SERVICE INFORMATION NO. SI 40-048/a

GARMIN: GTX 330/330D, GTX 33/33D Software Upgrade to Version 4.06 for non-G1000 applications only

SOFTWARE SERVICE BULLETIN

NO.: 0626

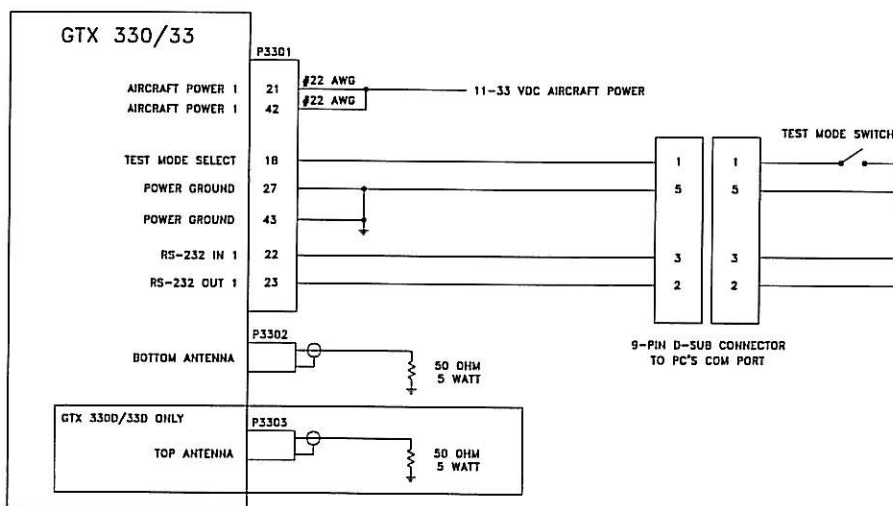
1. Use a test harness for the GTX 330/GTX 33 as shown in the following figure:

If the unit is removed from the aircraft and operated, always connect J3302, (J3303 for GTX 330D/GTX 33D) to an antenna or a 50 Ω , 5-watt load. The GTX 330/GTX 33 transmits Mode S acquisition squitter replies once per second whether interrogations are received or not. Failure to connect a dummy load during this procedure will cause the transponder to fail.

2. Ensure that the unit is turned off. Connect the GTX 330/GTX 33 to the test harness and apply power to the harness.
3. With the unit off, enable test mode via the Test Mode Switch. (Applies a ground to P3301 pin 18).
4. From the target directory (C:/Garmin) that the update software was saved to (from the Garmin website), double click on the file '330UPD14.exe'. This will create four additional files in the target directory. Verify the files are named as follows:
 - 006B0172.01R
 - AVXRGN32.EXE
 - README.TXT
 - UPLOAD14.BAT
5. Connect the 9-pin D-Sub connector of the test harness to a free serial port (COM 1 or 2) on the PC and apply power.
6. Turn the GTX 330 unit on. (The GTX 33 will turn on by the application of power.) The GTX 330 unit will be in test mode and show a dynamic test screen.
